WURLITZER SERVICE SLANTS

All Wurlitzer Model 3500 Series 200 Selection Phonographs equipped with Dollar Bill Accepters and shipped from the factory prior to Serial Number 765688.

Figure 1

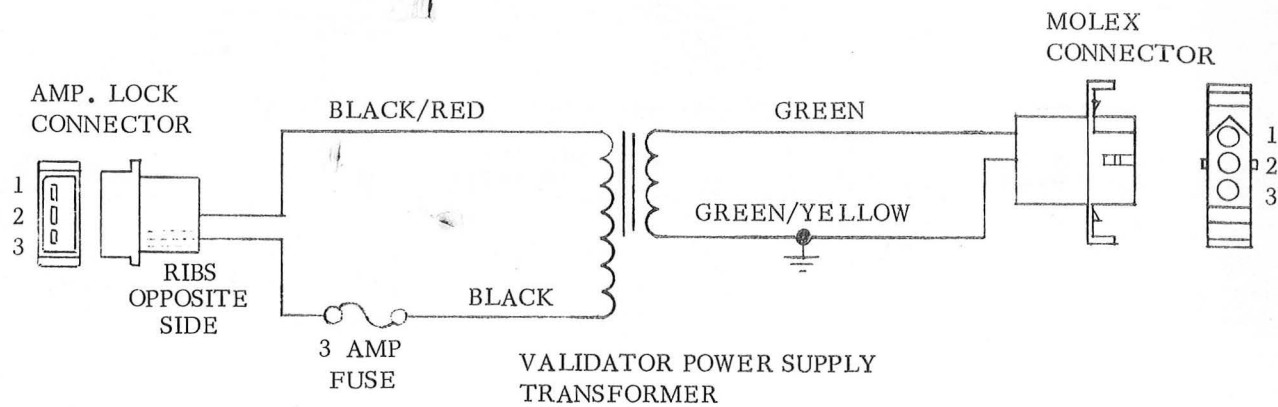
Possible shock hazard.

Phase of Validator Power Supply polarity reversed.

If it is found that the wiring disagrees with the connections stated in Step 7, push pins out of connectors and reinsert correctly. Refer to Figure 1.

1. Open Phonograph and Dome Assembly and remove Service Door.
2. Disconnect Validator Power Supply Cable plug from VALIDATOR receptacle located on Phonograph Power Supply.
3. Loosen latches securing Record Changer and slide Record Changer forward.
4. Remove necessary covers from Cable Retainer Channels.
5. Disconnect remaining Validator Power Supply cable.
6. Remove and retain two screws securing Validator Power Supply to floor of Phonograph cabinet.
7. Remove Validator Power Supply from cabinet and inspect cables for proper phasing. The cables should be wired to the transformer as follows:
 - a. Short Cable (Molex Connector).
 - Pin #1 to Green wire.
 - Pin #2 to Green/Yellow wire (ground).
 - b. Long Cable (Amp. Lock Connector).
 - Pin #1 (without ribs) no connection.
 - Pin #2 (center pin) to Red/Black wire.
 - Pin #3 (with ribs) to Black wire of fuse holder.
